TO: PROSPECTIVE BIDDERS HOLDING PLANS AND SPECIFICATIONS FOR
CITY OF RALEIGH CONTRACT ES 2023-04

RE: FY23 TRAFFIC CALMING AND WILD WOOD FOREST ELEMENTARY SCHOOL SIDEWALK
PROJECTS ADDENDUM NO. 2

24

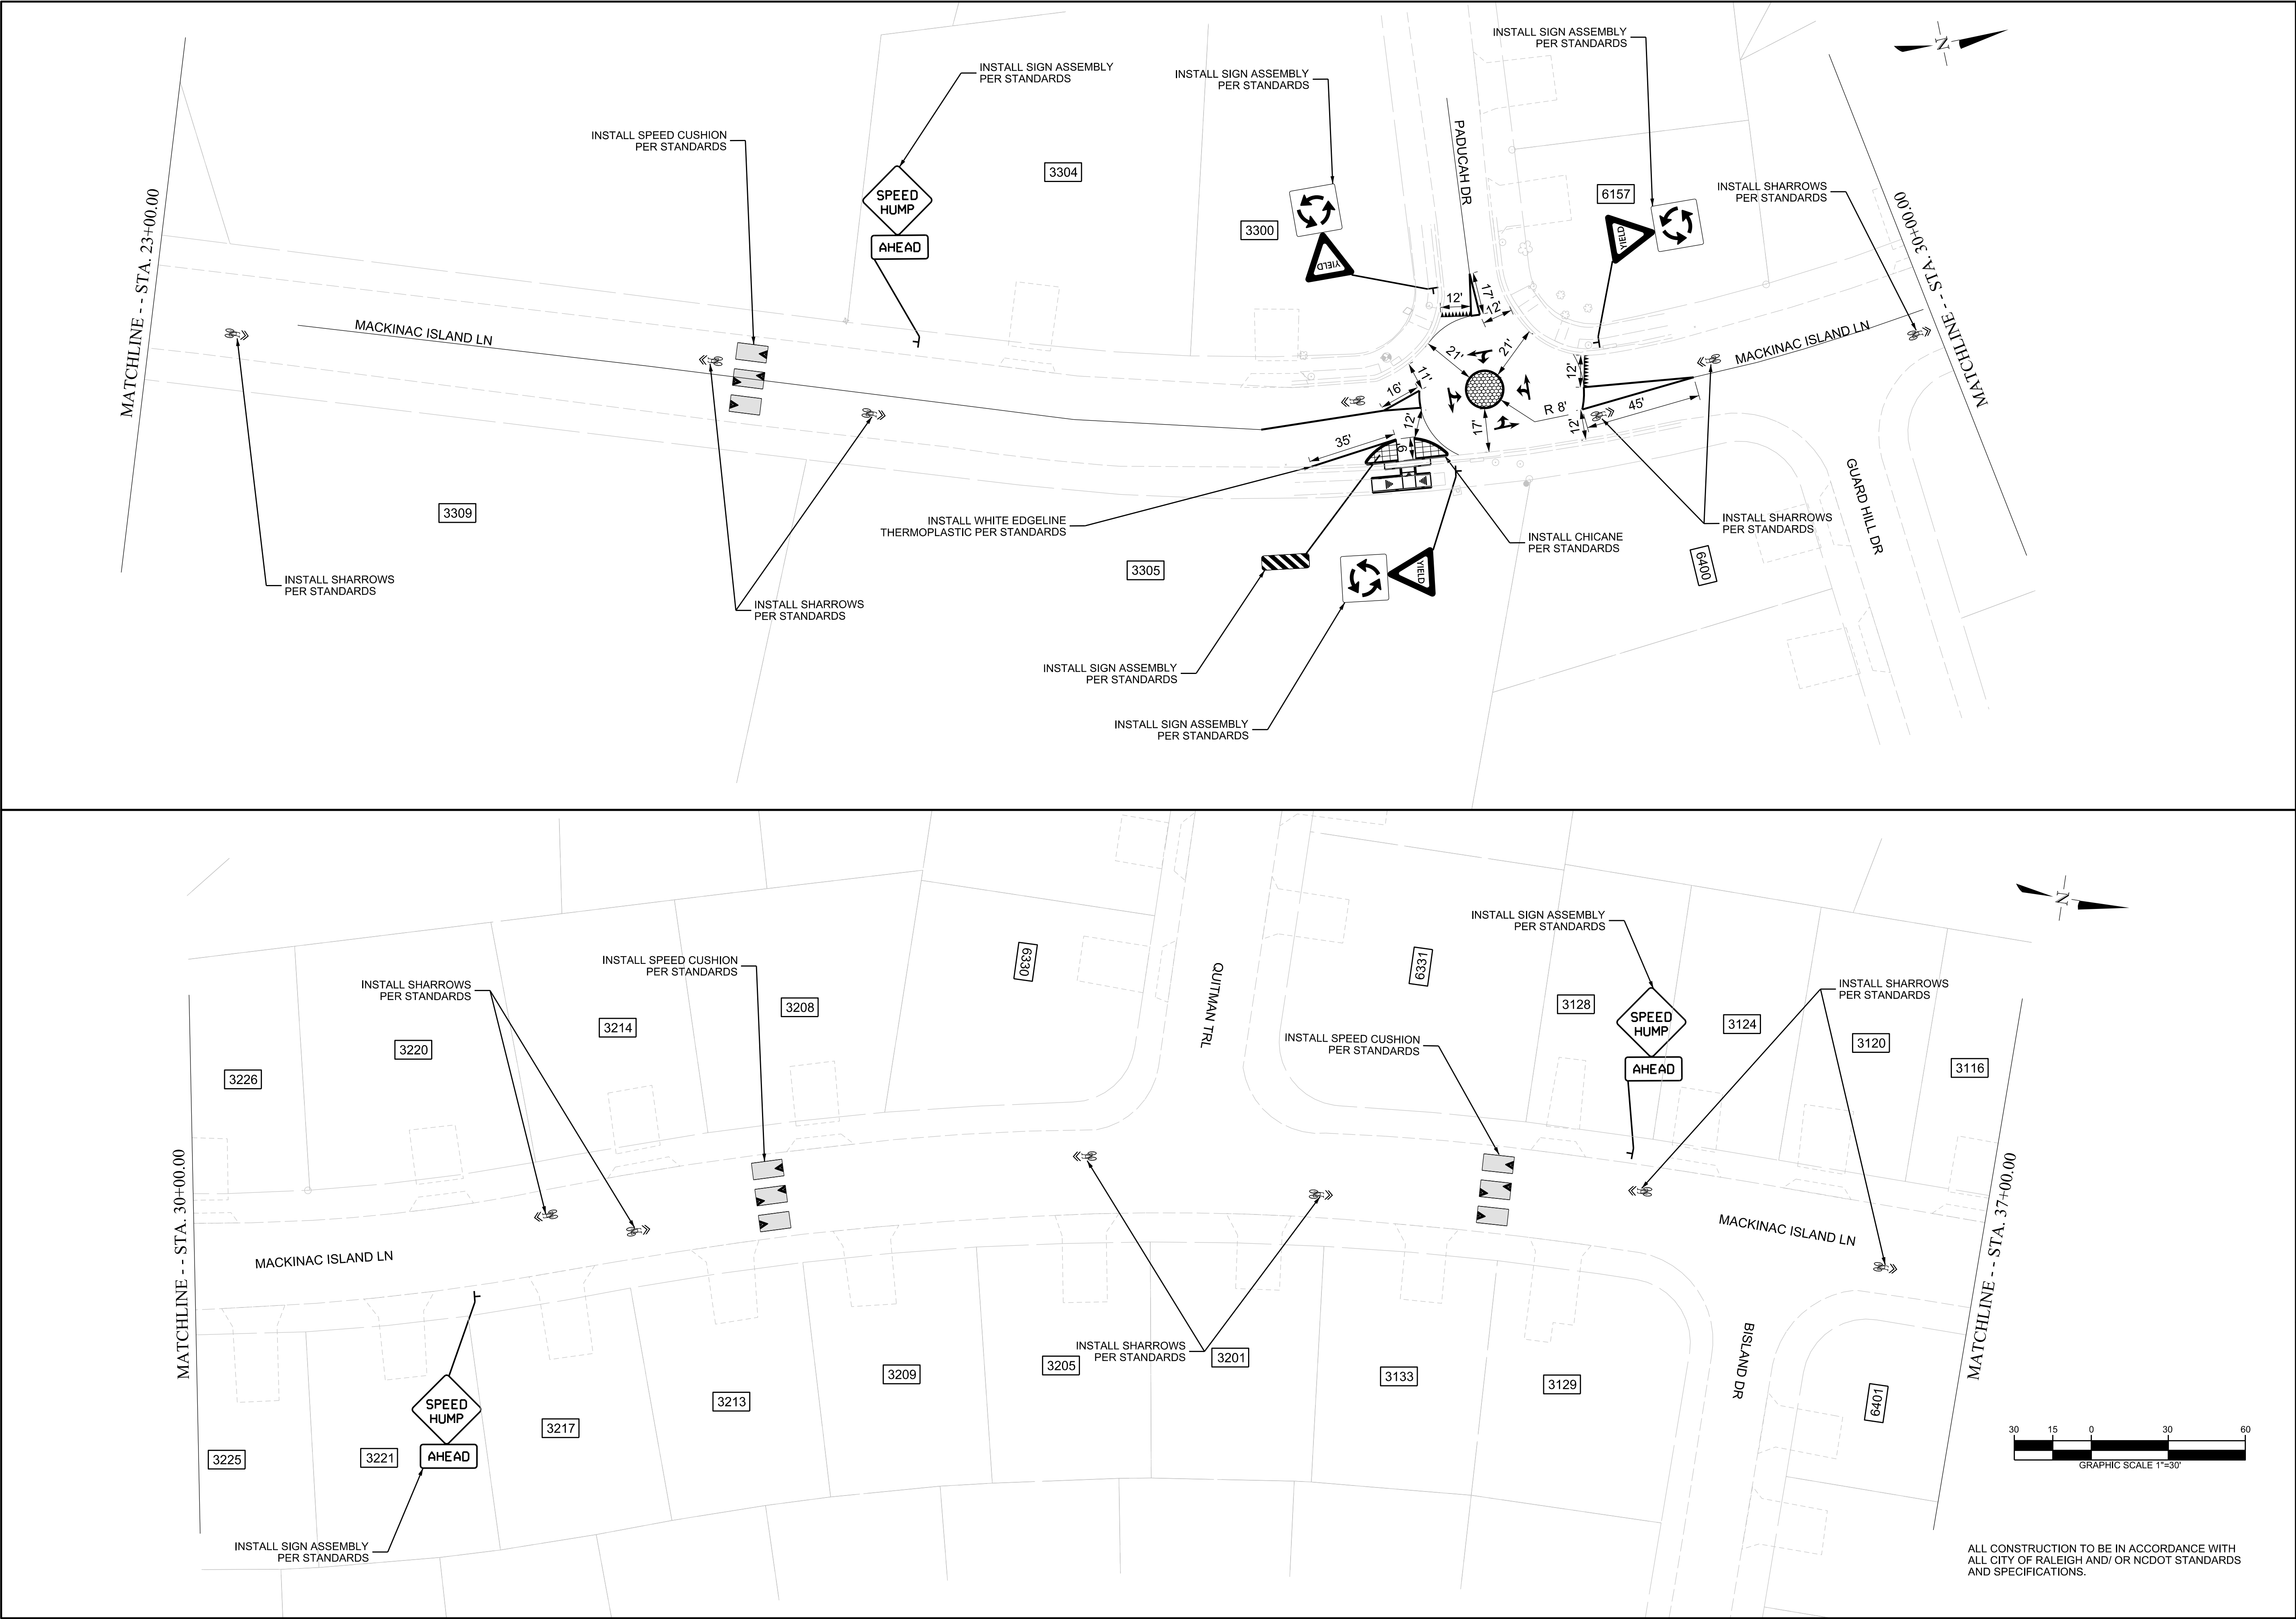
Mackinac Island Plan has been updated to show 2 signs added on sheet # 24.
Sierra Dr Plan has been updated to show 26 sharrows added on the Plan.

Question: On Mackinac Island Lane possibly 6 Speed Hump Ahead Signs are missing

Answer: *2 speed hump with ahead advisory plaque signs are missing on page 24 and will be added on the plan.*

SIERRA DRIVE
TRAFFIC CALMING PROJECT
FROM LINEBERRY DRIVE
TO LAKE WHEELER ROAD

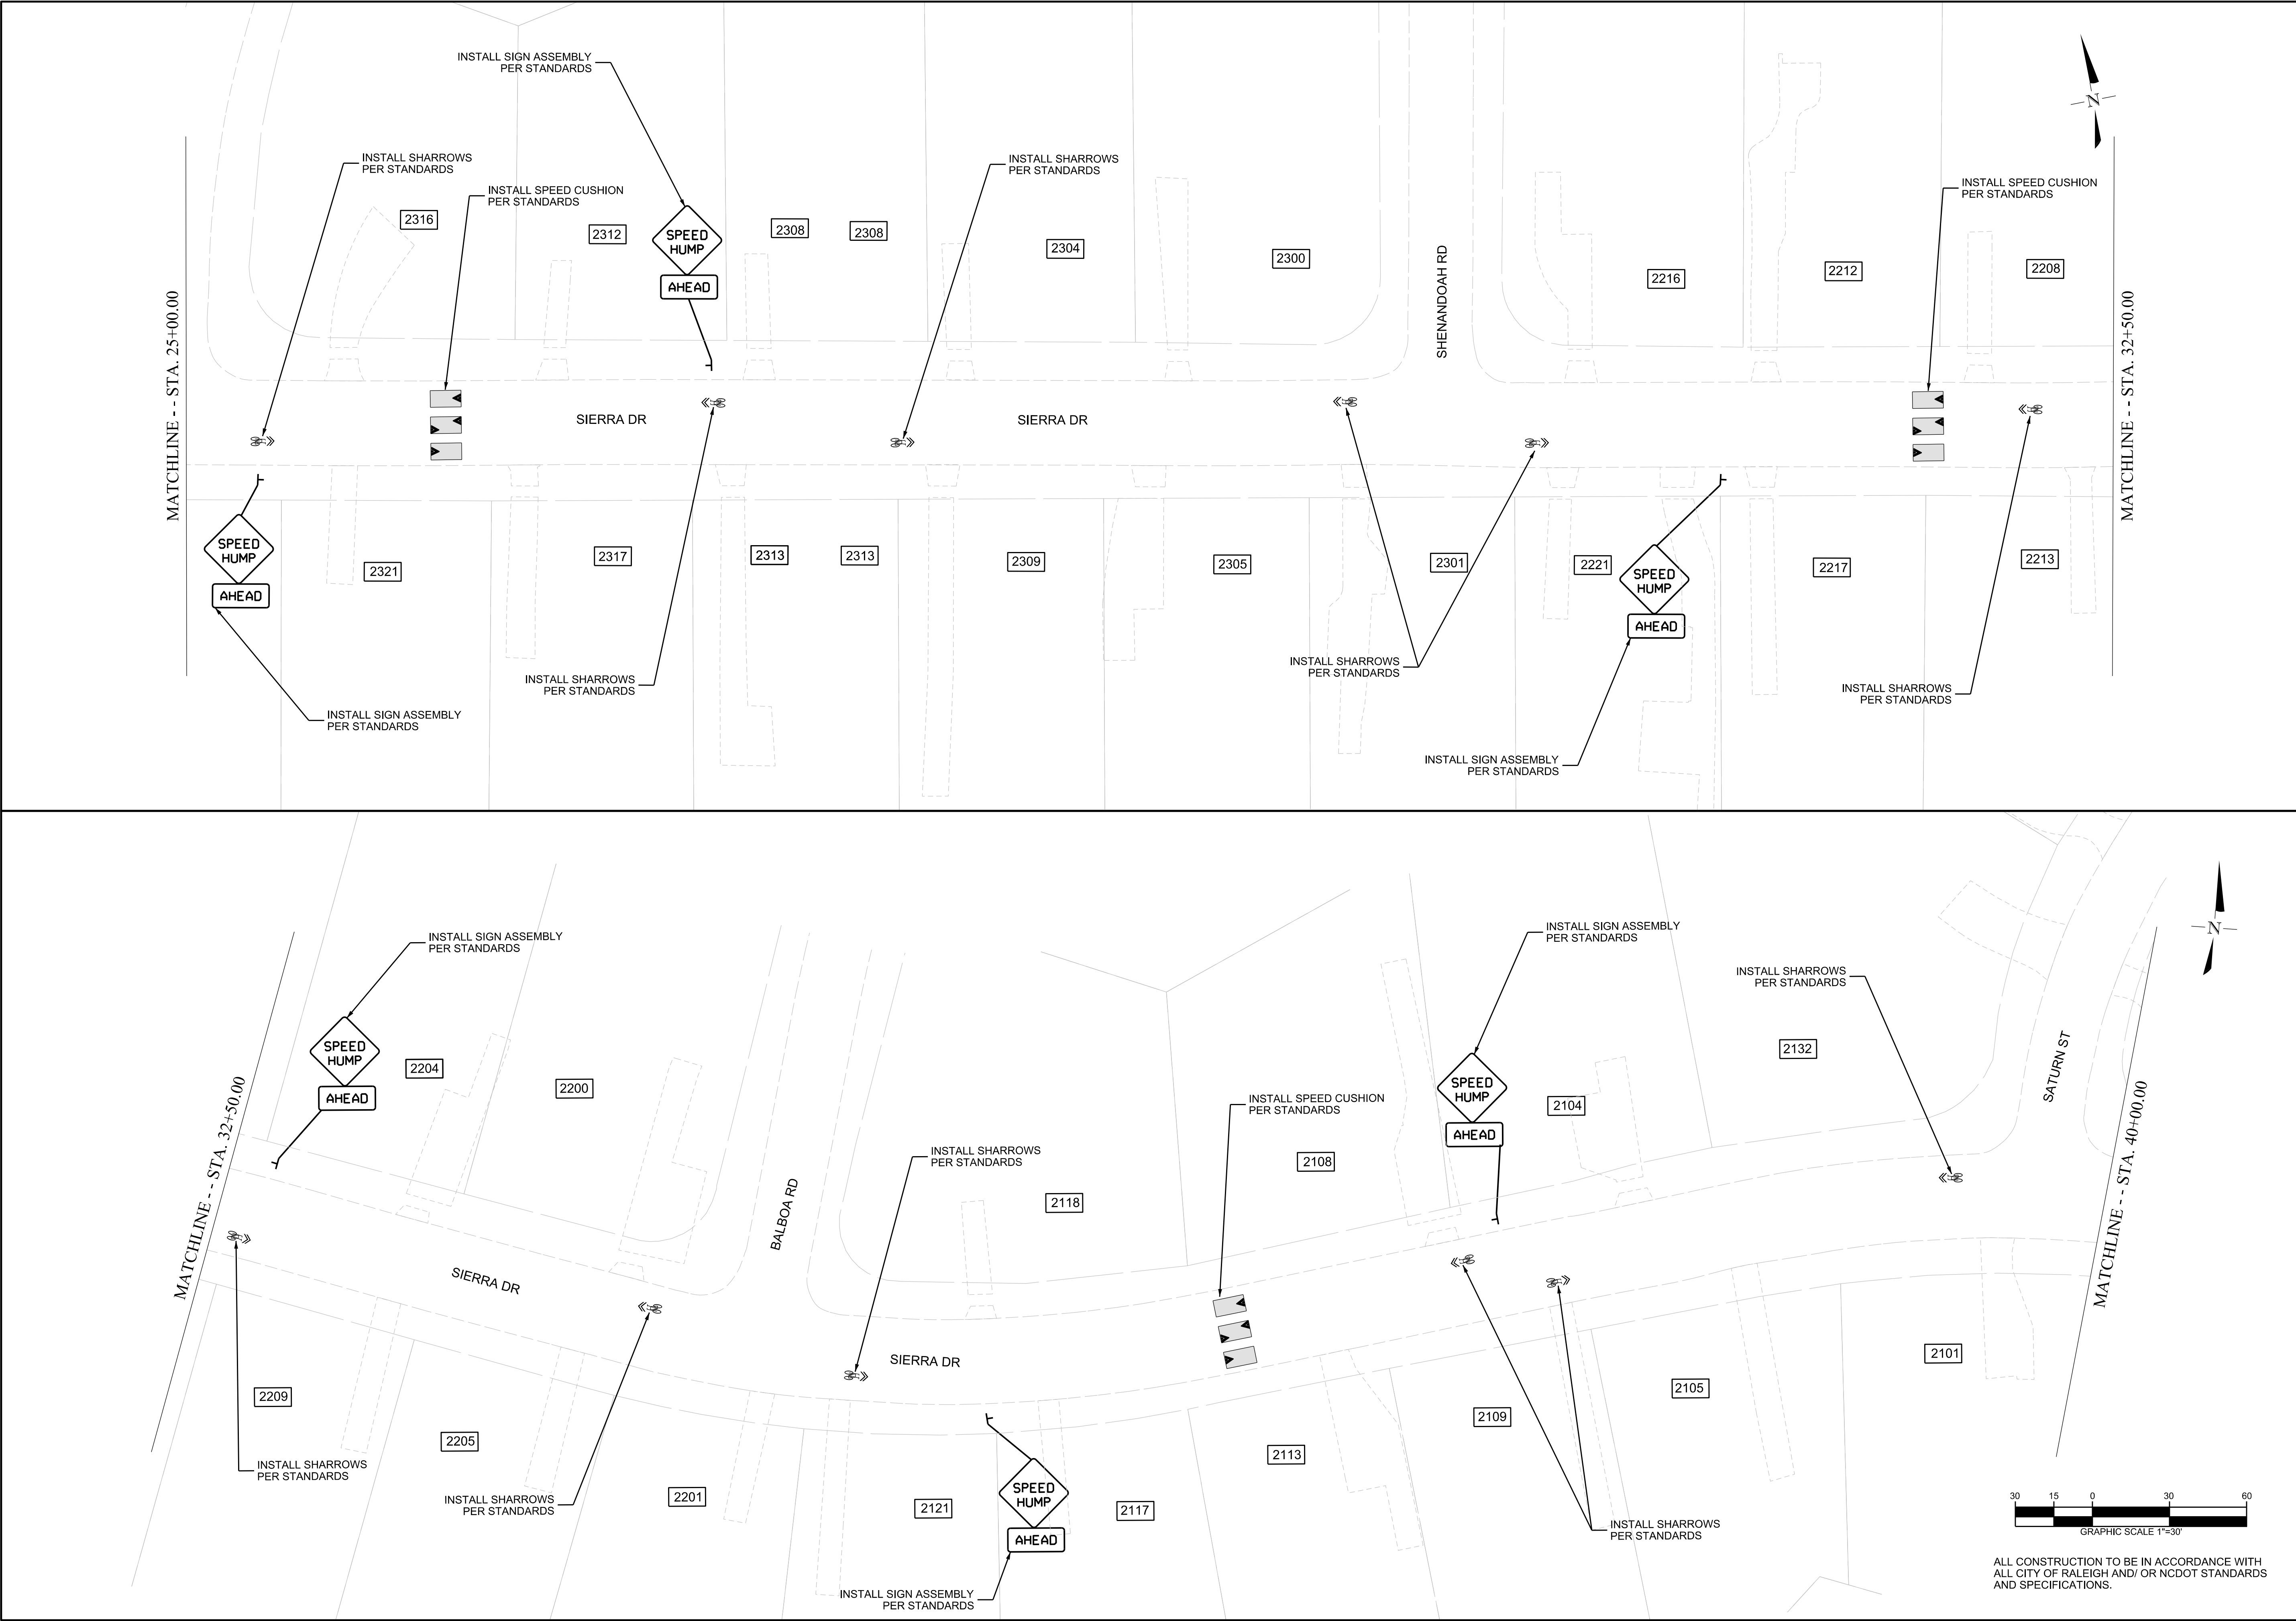
Question: Sierra Dr is about 38 ' wide and does not have existing bike lanes or sharrows on the road from google earth

Answer: *26 sharrow markings are missing on this street and will be added on the plan.*
